12.2

Planning Application P516/2023 for 52 - 56 Selwyn Street, Albion

For Council to consider planning application P516/2023 for the construction of ten double storey dwellings and a reduction to the standard car parking requirement (visitor spaces) at 52 – 56 Selwyn Street, Albion, against the provisions of the Brimbank Planning Scheme.

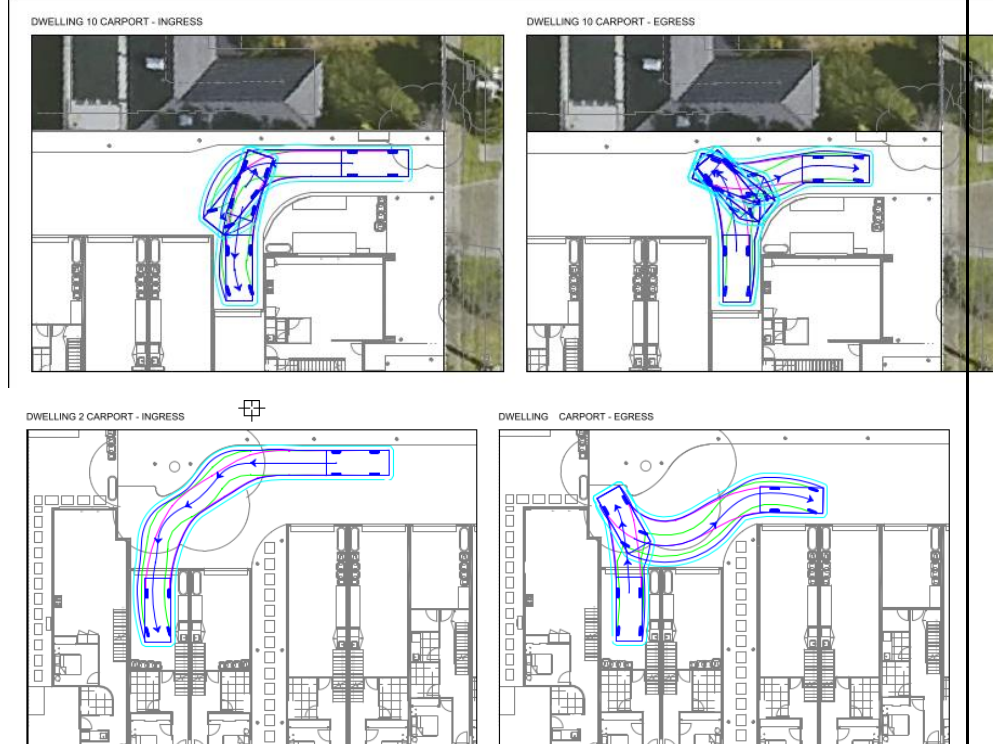
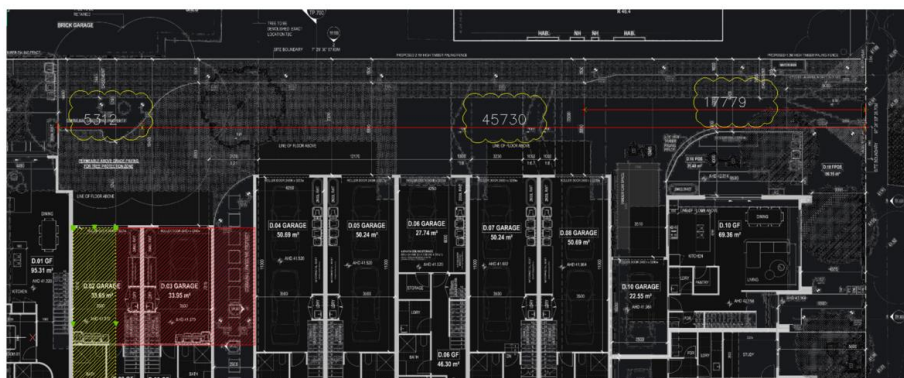
- In terms of the passing area requirements of the Scheme further information has been provided by Traffix Group traffic engineers on behalf of the applicant:

- o The length of accessway that provides "shared" access is only 45.7m long i.e. the last 5.3m is used solely to access the last dwelling. Referencing the shared length of the accessway, the proposal arguably does not exceed the 50m trigger. This is shown below:

Whilst the above is noted in order to address Council's Traffic Engineering concerns regarding constrained movements within the site a condition of permit will require the accessway fronting dwellings 4 - 8 be increased from 5.8 metres to 6.1 metres by reducing the floor area of dwellings 4 - 8. This will create a passing area 6.1 metres wide for 29 metres in length. In addition the following standard conditions of permit will apply:

Endorsed Ground Floor Plans (P0787/2017): 58 Selwyn Street, Albion

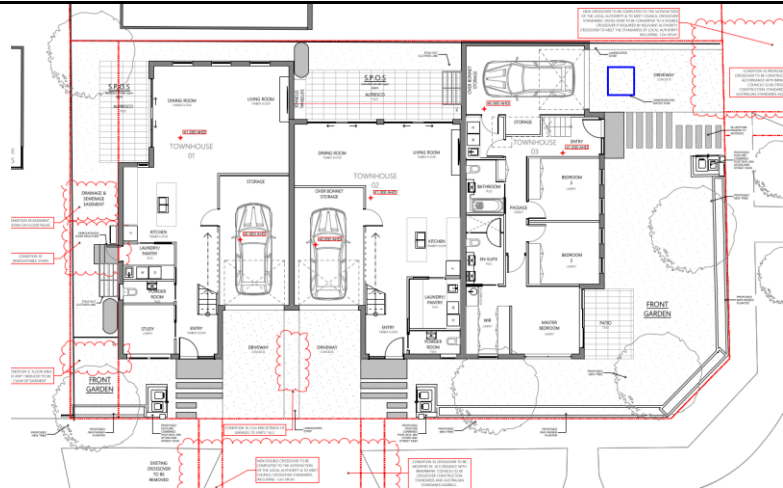
- The proposed development albeit on a larger scale, clearly reflects the design principles of the 3 unit development near completion on the lot directly to the south at 58 Selwyn Street, at the intersection with Dalworth Street/ Selwyn Street approved under Planning Permit P0787/2017 shown below.
